DEVELOPMENT REVIEW COMMITTEE (DRC) COMMENT REPORT

PROJECT NAME: Coral Ridge Publix

CASE NUMBER: UDP-S23044

REQUEST: Site Plan Level II Review: 67,043 Square Foot Grocery Store

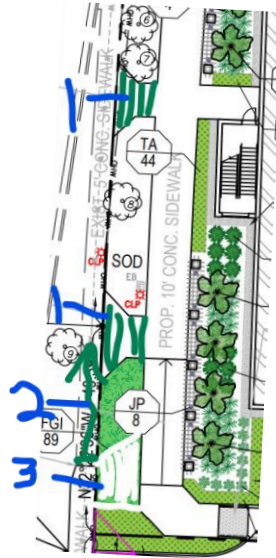
7. Section 47-21.12. A.3. Interior landscape area. At least thirty (30) square feet of interior landscape area shall be provided for every interior parking and loading space and shall not be part of any perimeter landscape area. Please provide calculations and demonstrate interior landscape area requirements of square footage is being met.

8. Please provide alternative design to the cart corral whereas a tree island is to provide interior landscape area and canopy tree. Please allow the Department to suggest that may benefit the site in meeting requirements. The parking stalls appear to be proposed at ten feet width. Utilizing two parking stalls would allow the larger shade trees (15 feet width planting area) and allow for the four to five feet width for the cart corral. If there is adequate space, there could be a possible hedge between the cart corral and adjacent parking stall along with a concrete curb. A somewhat similar set up was provided at the Publix at 1744 N Federal HWY.

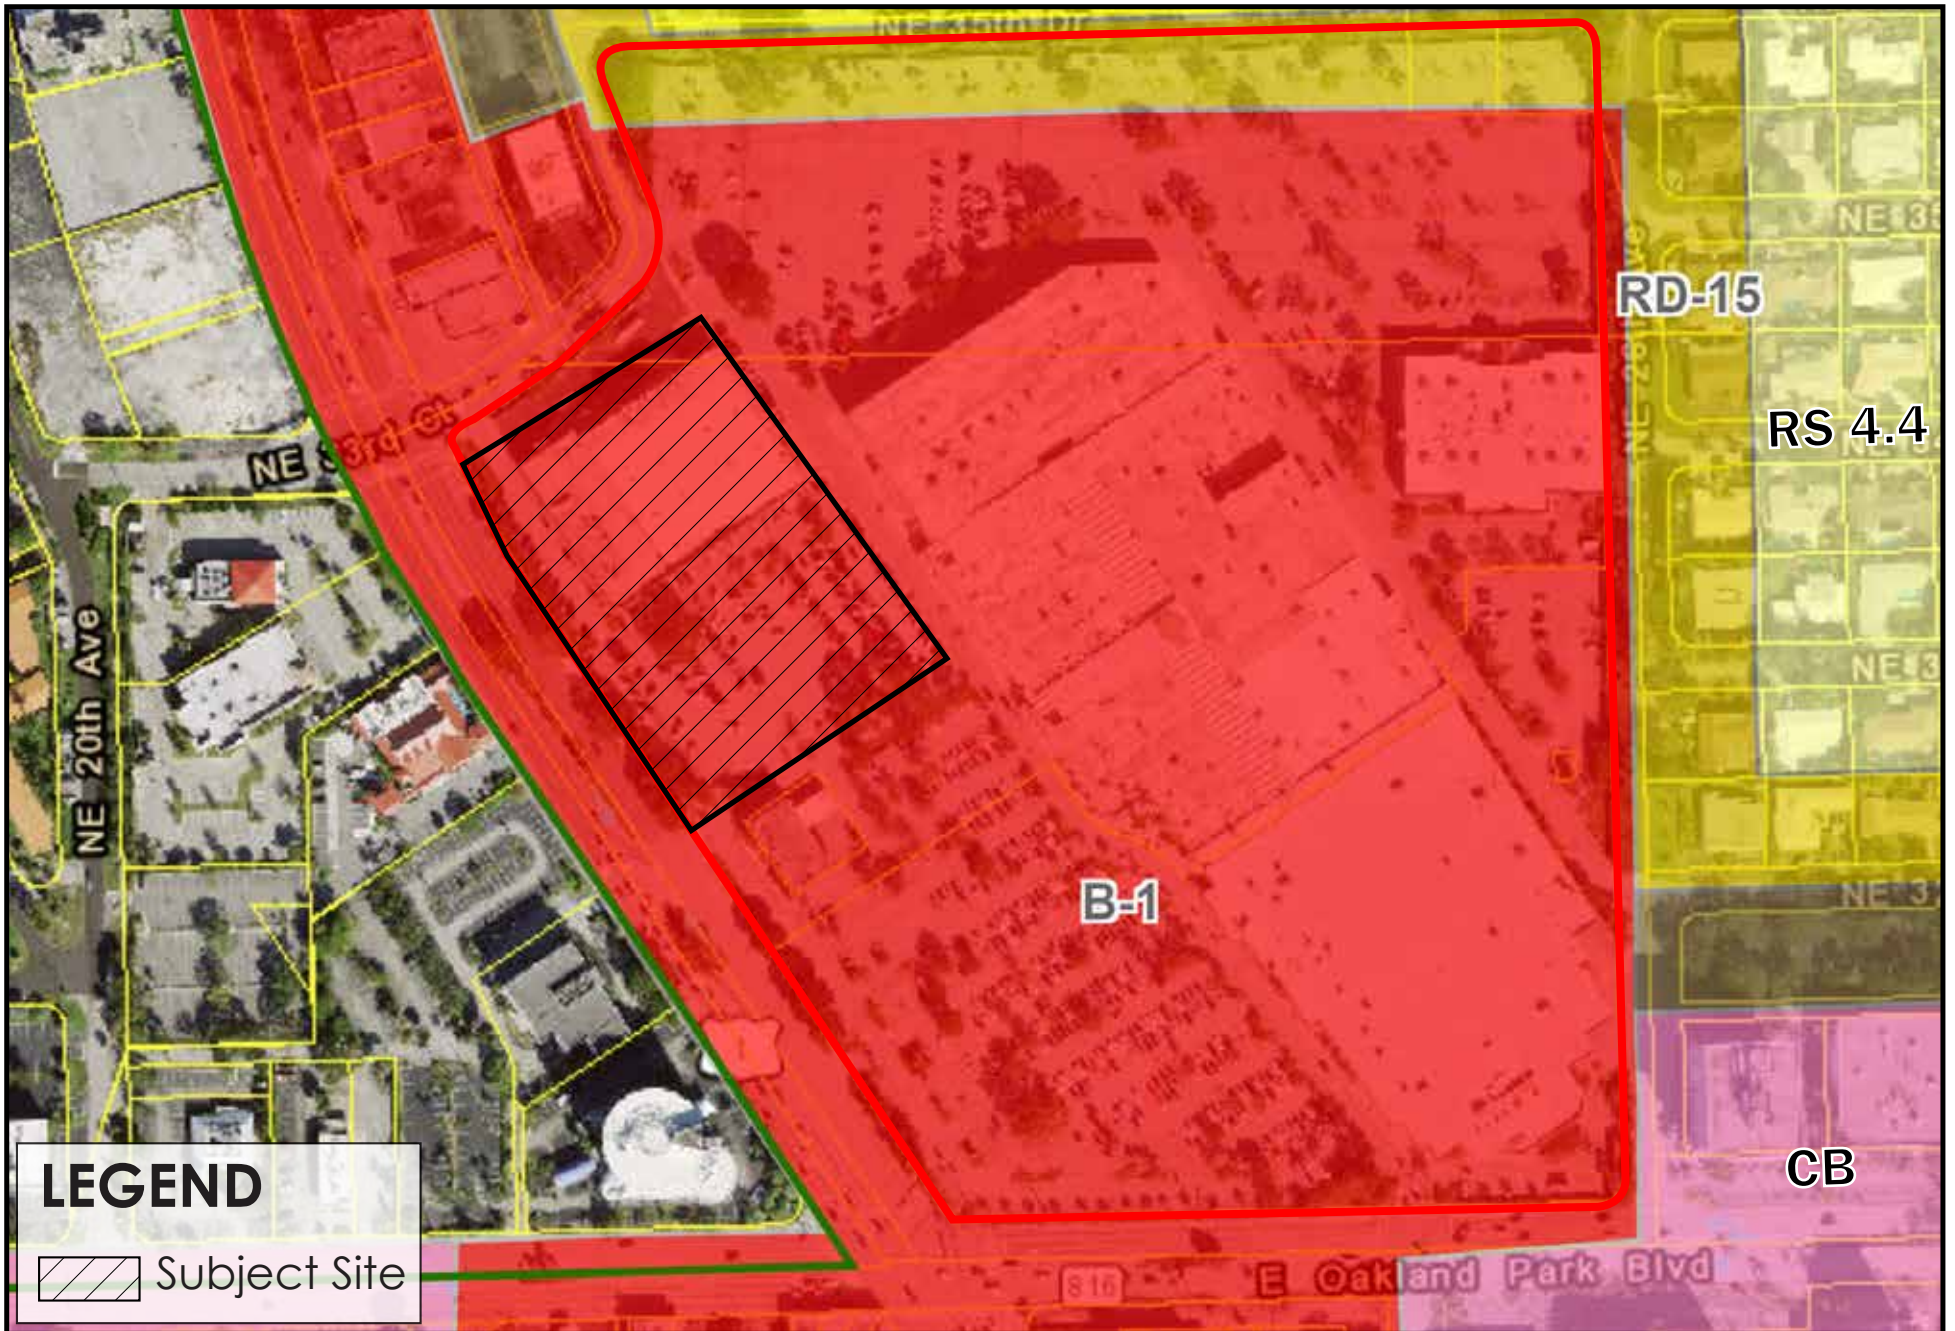
5. A separate application to vacate the drainage easement along Federal Highway must be submitted.
6. As proposed, the site layout creates safety and design issues with pedestrian and vehicular conflicts at the southwest corner of the building adjacent to Federal Highway. The ground level is parking with the customer entrance shifted away from the corner thereby creating a disconnect to the public realm. The multiple vehicular movements at this corner are unsafe and will create stacking with back-up onto Federal Highway. Applicant must address ULDR regulations for interdistrict and parking design standards to resolve these issues. This was discussed during the preliminary development meeting with staff; however, the formally submitted plans did not address these issues. The following should be considered: (1) Remove the ingress/egress into the parking garage at the southwest corner of the building, (2) shift the customer entrance and liquor store entrance toward Federal Highway to activate the corner and create ground level activity, and (3) enhance the frontage along Federal Highway both from pedestrian experience and activation. See images below for reference.
